LOCATION #1:
ROONEY & EDENVALE

DEVIATION REQUEST AND DECISION FORM

Project Name :	GRANDVIEW PHASE 2 (PUDSP-23-006)
Schedule No.(s) :	4200000475, 4200000474
Legal Description :	A TRACT OF LAND BEING A PORTION SECTION 21, AND A PORTION OF THE NORTHEAST QUARTER OF SECTION 28, TOWNSHIP 12 SOUTH, RANGE 64 WEST OF THE 6TH/ PRINCIPAL MERIDIAN, EL PASO COUNTY, COLORADO

LOCATION #2:
SCONE & DOWNPATRIC

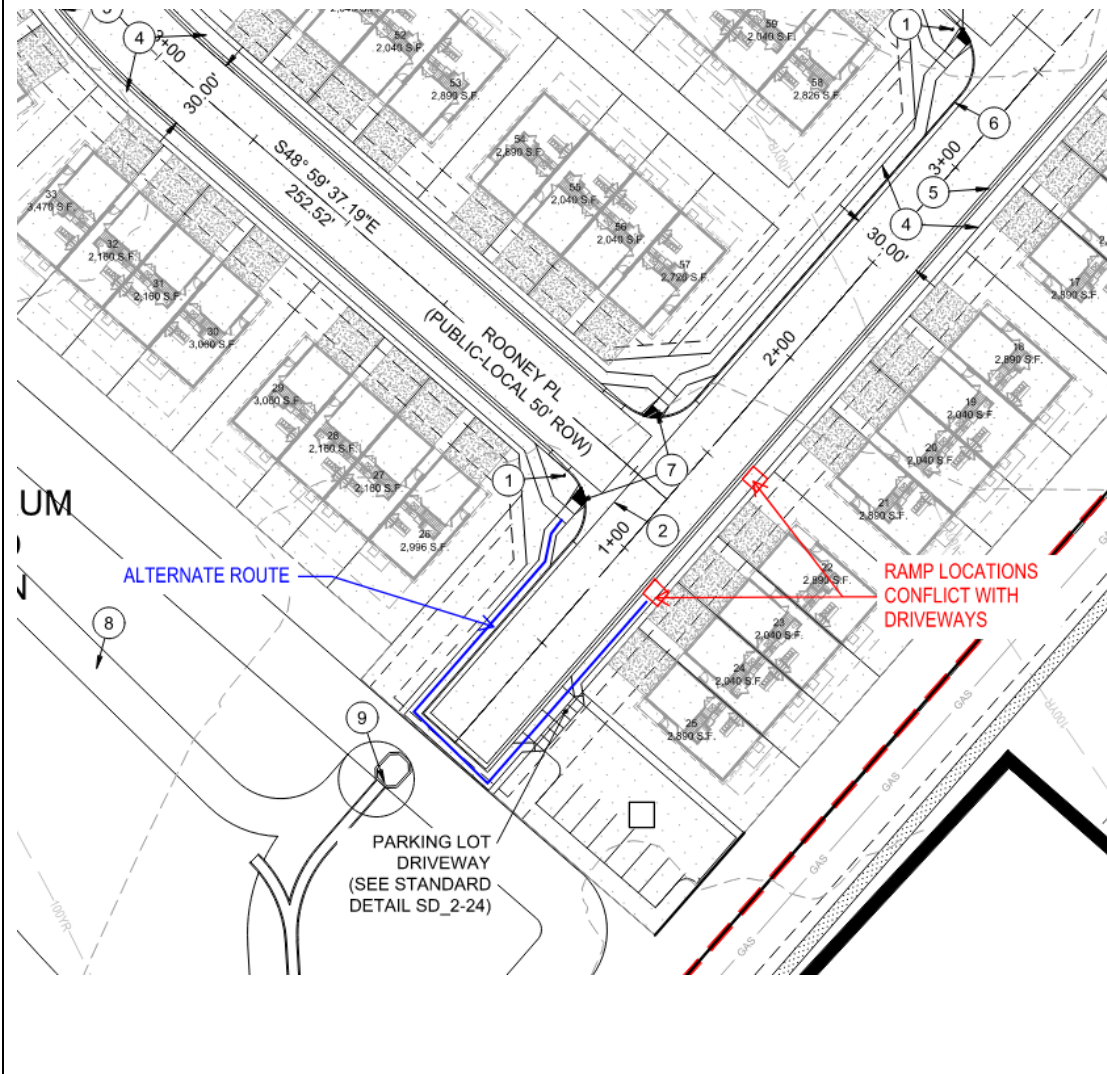
All "T" intersections shall have a minimum of three access ramps as shown in Figure 2-36. A private access may be used as an access ramp provided it is designed to meet ramp requirements and it is within the intersection and directly across from other ramps.

The townhome units are laid out in groups of 4 with very little separation between driveways. As a result, the access ramp will conflict with the driveways. (SEE EXHIBIT IN NEXT SECTION)

The alternative is to provide an alternate pedestrian crossing. In this location, the pedestrian can cross the street via an alternate route 95 feet south of the pedestrian ramp landing.

Additional space needed for a pedestrian crossing is not easily generated with the high-density townhome units. The design objective to safely transport pedestrians can be accomplished by rerouting the pedestrians slightly.

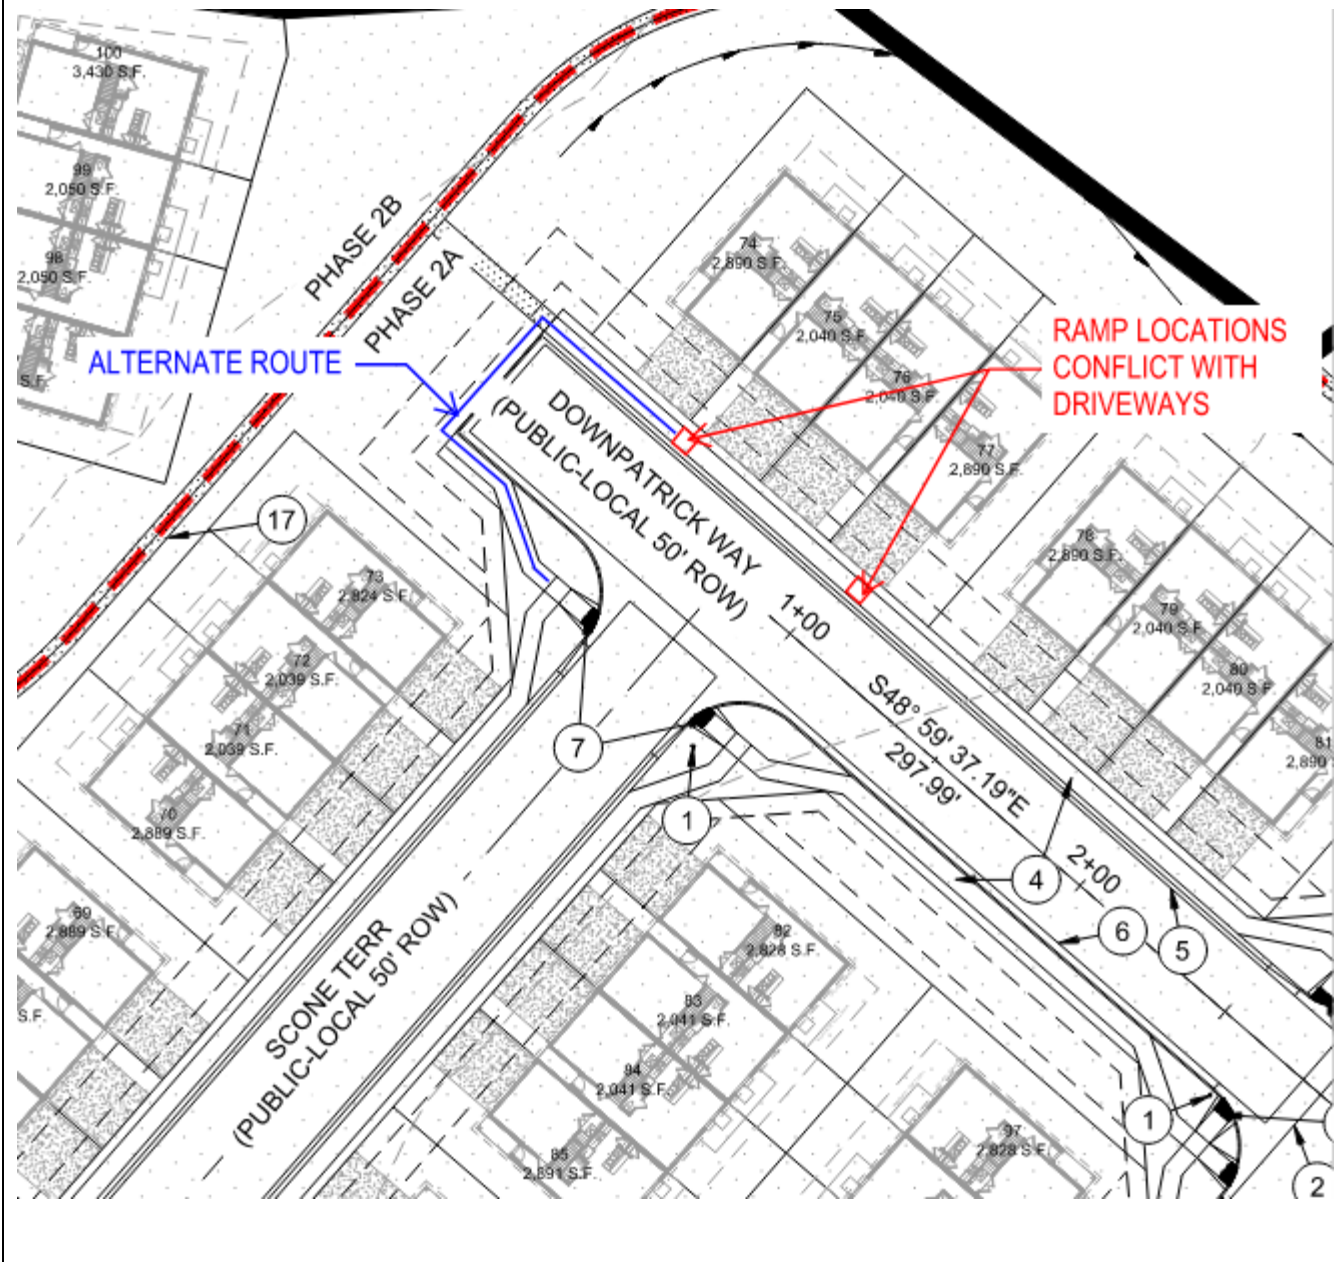
All "T" intersections shall have a minimum of three access ramps as shown in Figure 2-36. A private access may be used as an access ramp provided it is designed to meet ramp requirements and it is within the intersection and directly across from other ramps.

The townhome units are laid out in groups of 4 with very little separation between driveways. As a result, the access ramp will conflict with the driveways. (SEE EXHIBIT IN NEXT SECTION)

The alternative is to provide an alternate pedestrian crossing. In this location, the pedestrian can cross the street via an alternate route 50 feet northwest of the pedestrian ramp landing.

Additional space needed for a pedestrian crossing is not easily generated with the high-density townhome units. The design objective to safely transport pedestrians can be accomplished by rerouting the pedestrians.
